## *EVR Hose Configuration*

# Product Bulletin

## Commercial Availability

**ENHANCED VAPOR RECOVERY (EVR)-CERTIFIED REPLACEMENT PARTS FOR ORVR-COMPATIBLE BALANCE VAPOR RECOVERY SYSTEMS**

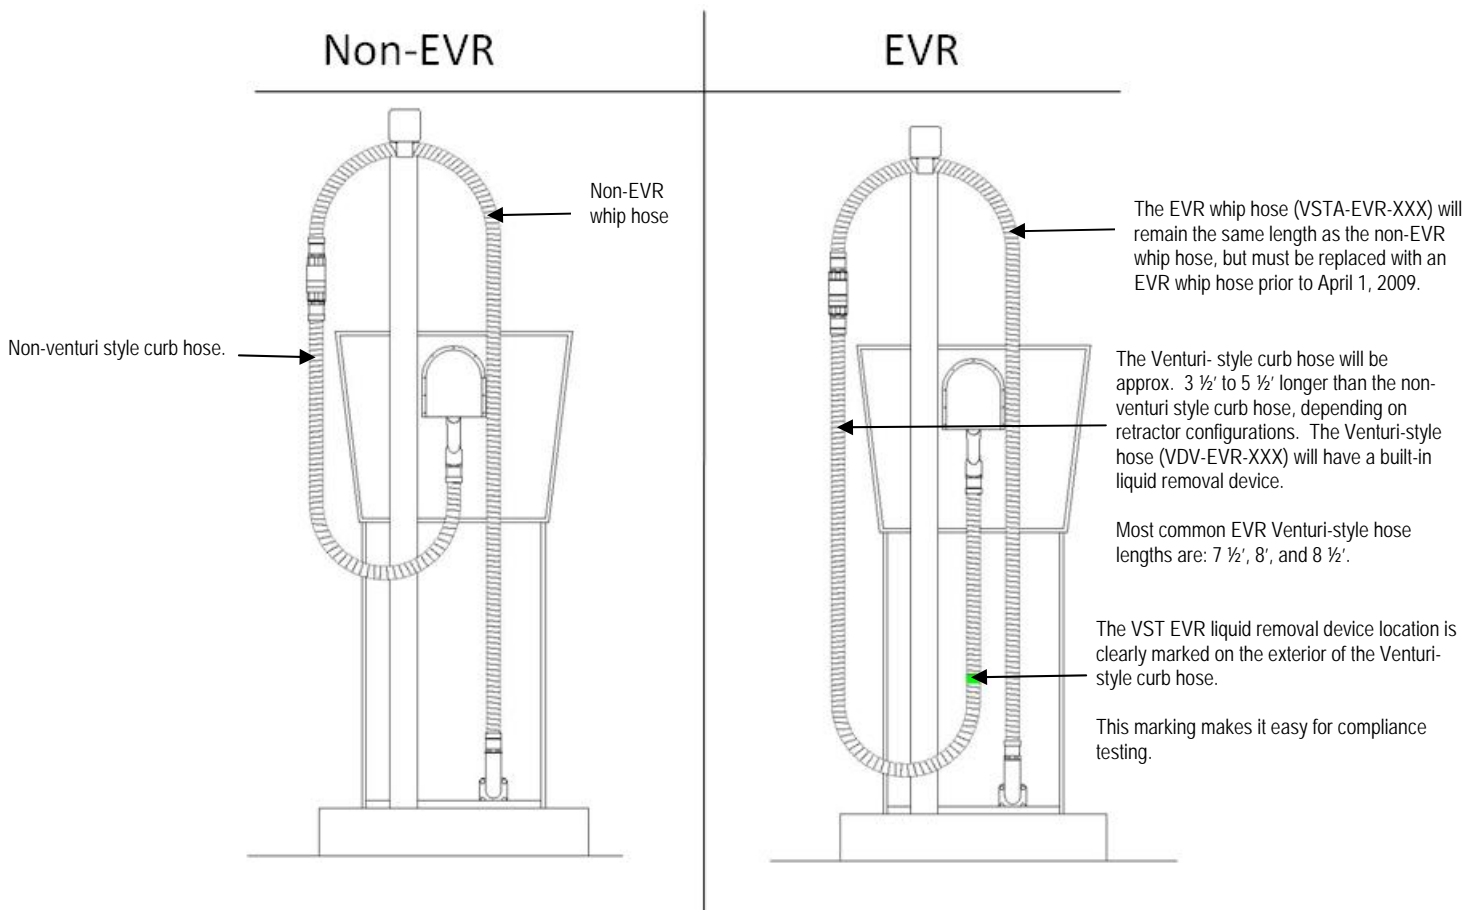
The purpose of this bulletin is to explain the correct EVR hose configuration when replacing a non-EVR hose with a VST EVR-approved curb hose. Additionally, CARB's Commercial Availability Advisory (see attached) becomes effective on November 1, 2008, requiring GDF owner / operators to begin replacing non-EVR hanging hardware with VST EVR-approved hanging hardware.

1. EVR-approved curb hoses must be a Venturi style, meaning they contain built-in liquid-removal devices.
  - VST is the only provider of Balance, EVR-approved, Venturi-style curb hoses.
2. Venturi hoses will be 3 ½' to 5 ½' longer than the existing non-EVR curb hose to allow the Venturi hose to function properly.
3. The whip hose will remain the same length. SEE DIAGRAM BELOW
